Title: ERID-111328 SUBMITTAL OF THE RESPONSE TO THE NOTICE OF DISAPPROVAL FOR THE INVESTIGATION WORK PLAN FOR LOWER PAJARITO CANYON AGGREGATE AREA AND REVISION 1, INCLUDING 2 CD'S, EP2010-0521, EP2010-0522, LA-UR-10-7635

To:(Addressees - Organization) JAMES BEARZI, NMED

From:(Senders - Organization) MICHAEL J GRAHAM, LANL
 GEORGE J RAE, DOE

Figure 4.8-1 Site features of SWMU 18-003(d)

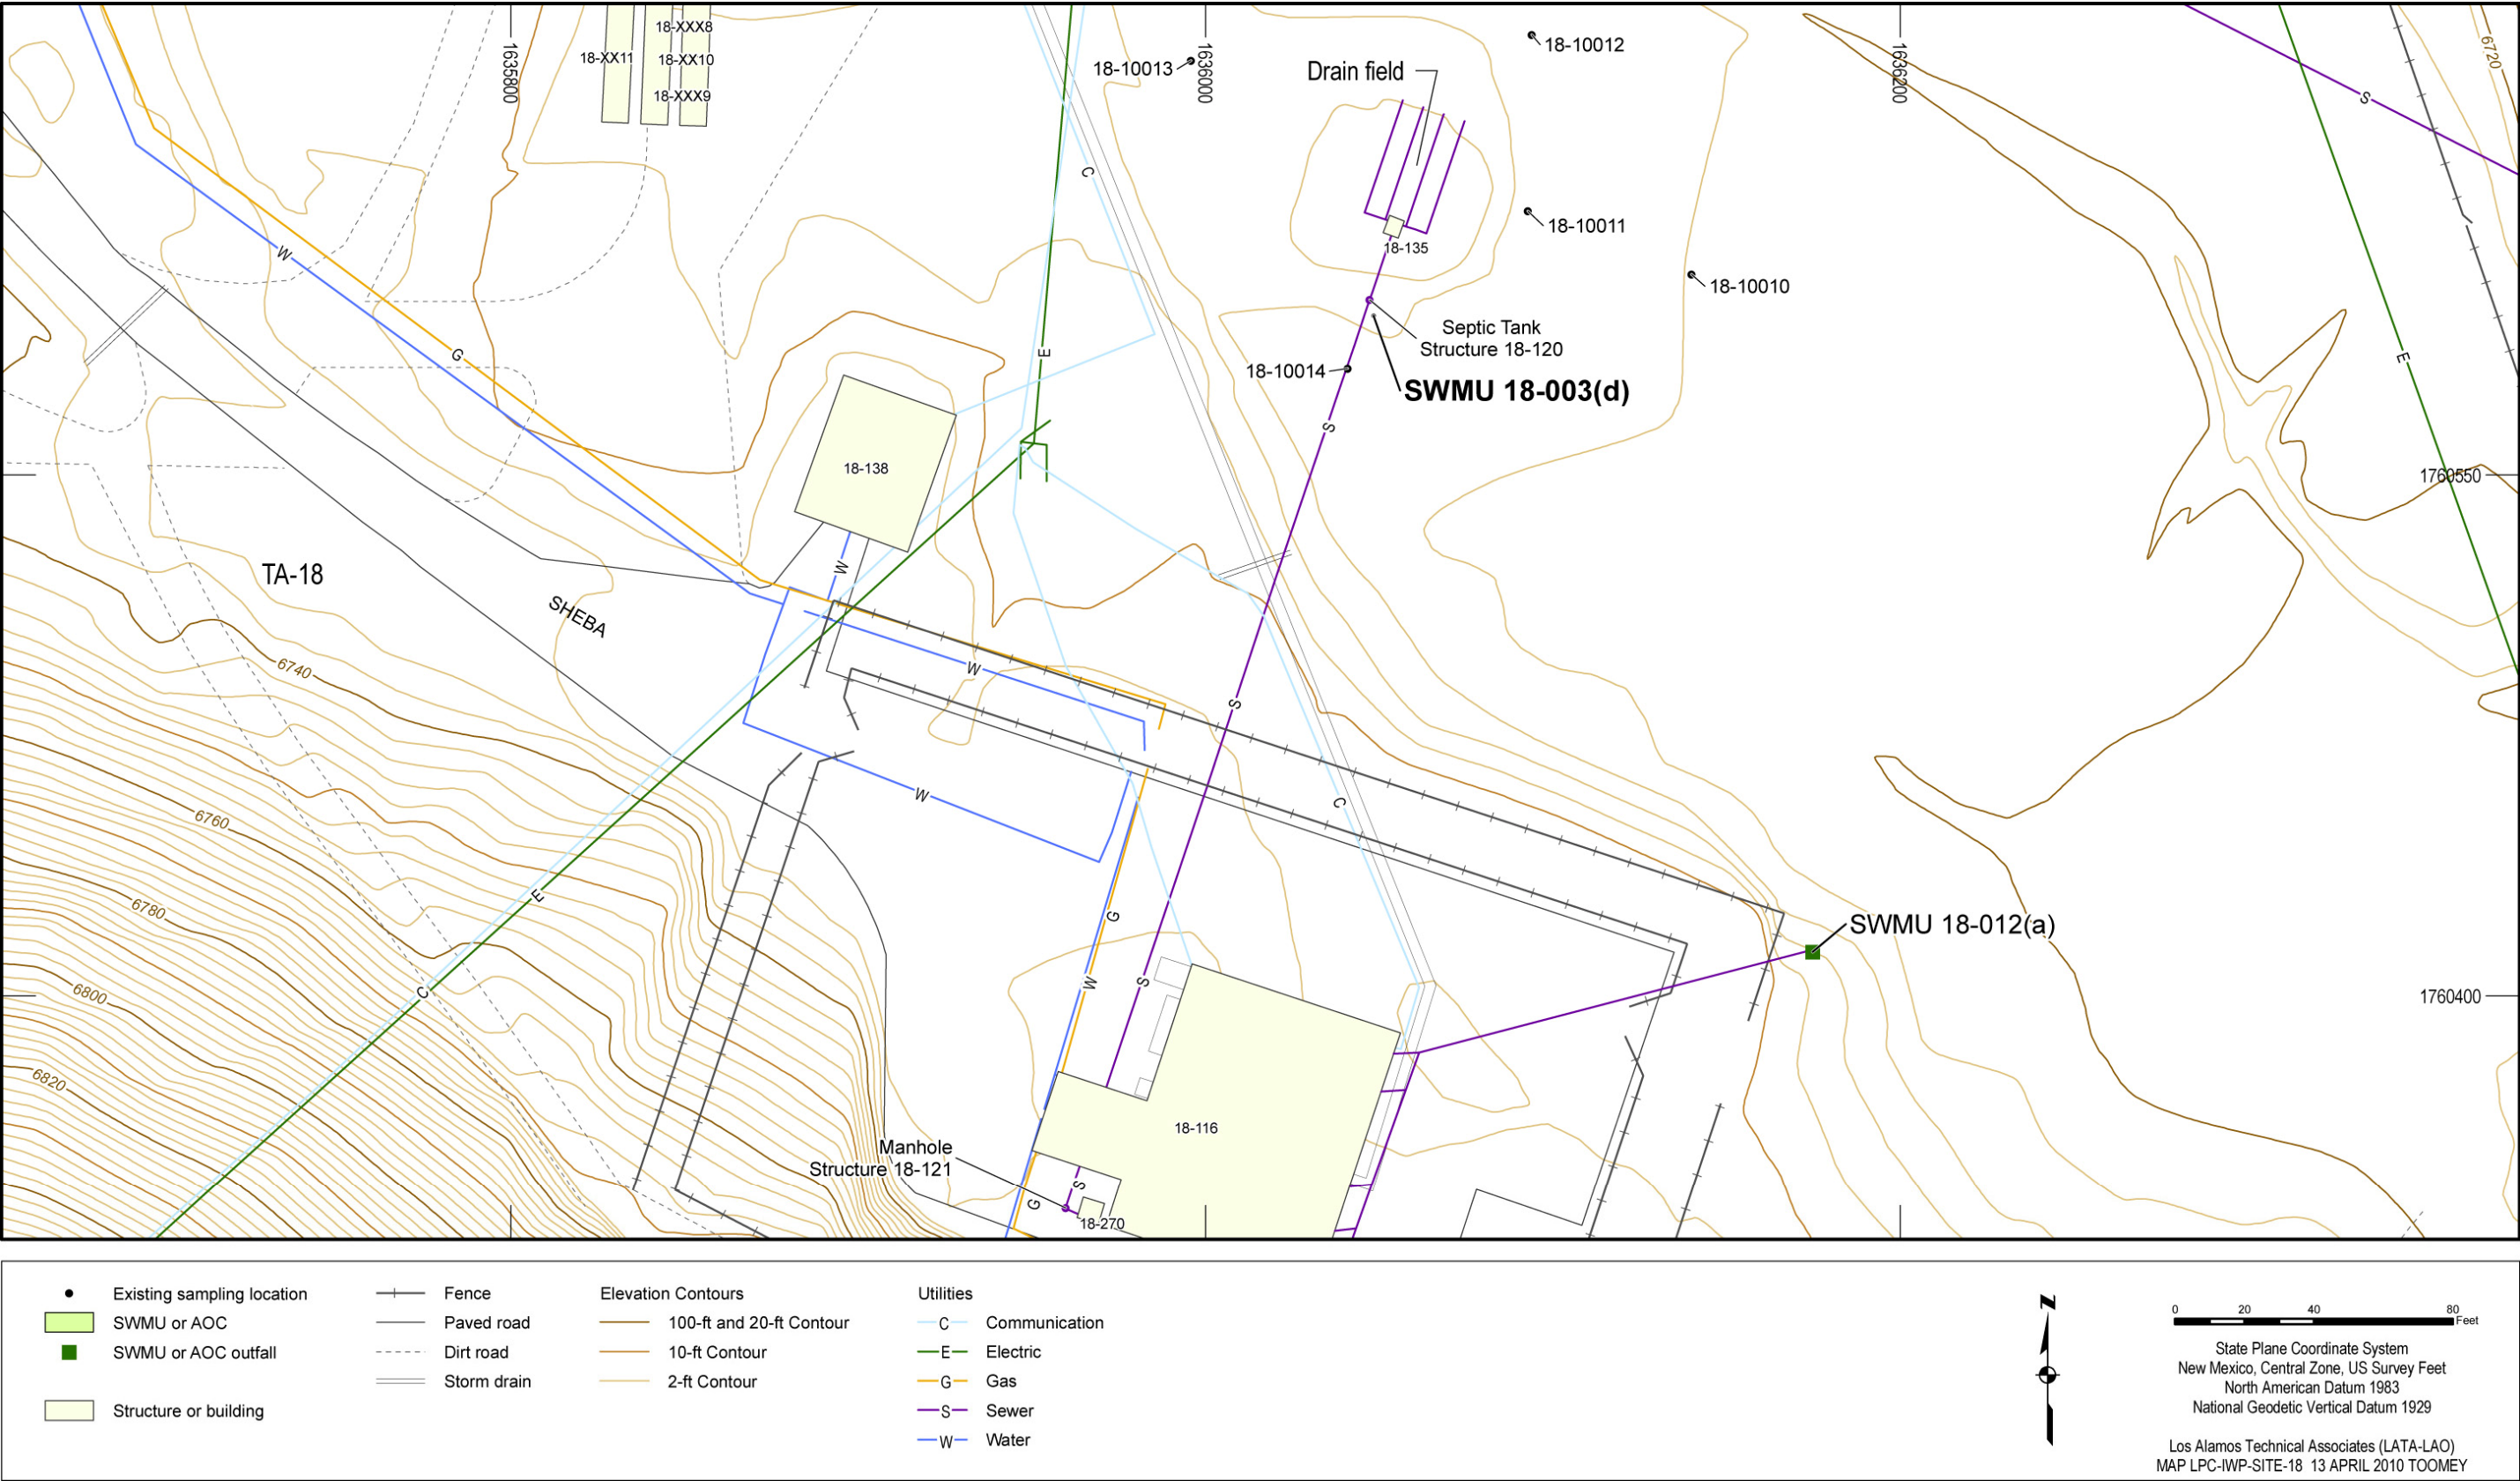
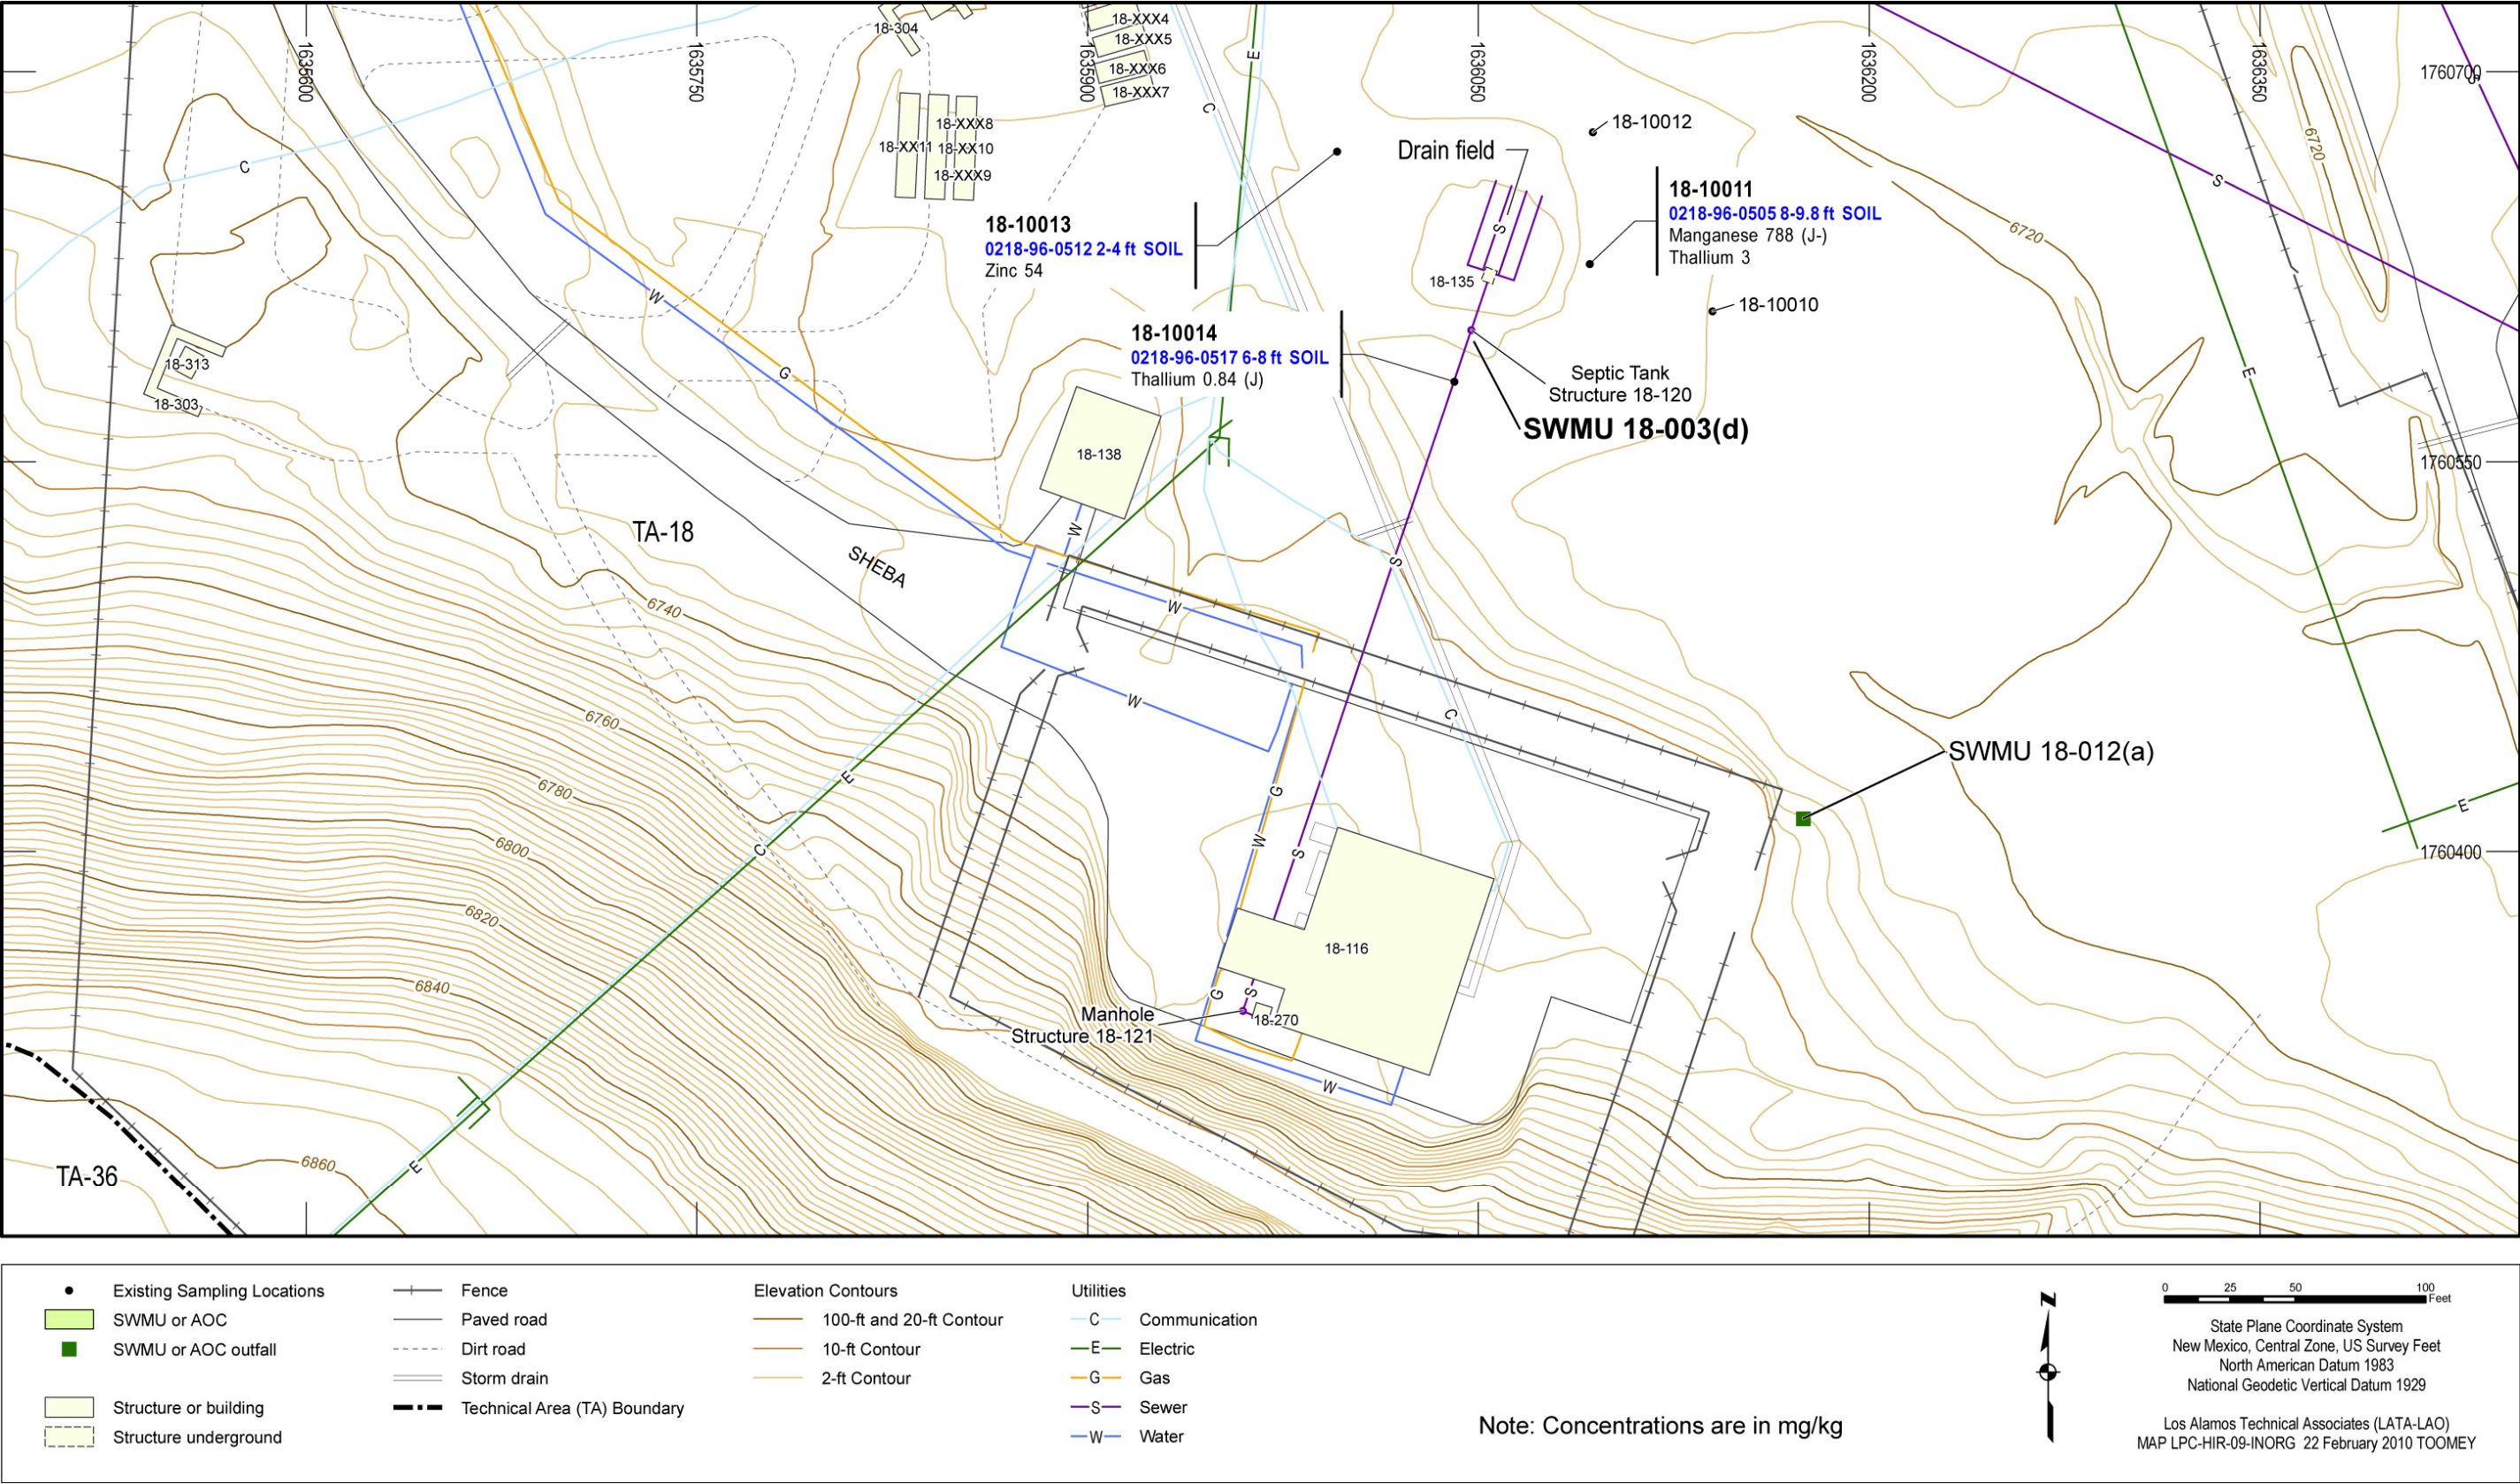
Plan Plate 1 shows several monitoring wells in the vicinity of this SWMU. If any monitoring wells are located within the site boundaries shown on Figures 4.8-1 through 4.8-4, the well(s) must be added to the figures. In the event one or more wells are added to the figures and, if the well(s) will be sampled in 2011, the monitoring results must be included in the IR.

NMED Comment: *The wells must be shown on Figures 4.8-1 through 4.8-4. If the well(s) will be sampled in 2011, the monitoring results must be included in the IR.*

12. Soil samples were collected from the monitoring wells when the wells were installed during the 1996–1998 VCA. Results from those samples are presented in section 4.8.2. The wells were subsequently abandoned and are no longer in use. The locations shown on Plate 1 are the existing sampling locations associated with the abandoned wells. The nearest active monitoring wells shown on Plate 1 are approximately 900 ft away from SWMU 18-003(d) and are not included in the site figures. The text in section 4.8.1 has been revised to clarify that the wells were abandoned and are no longer active monitoring wells.
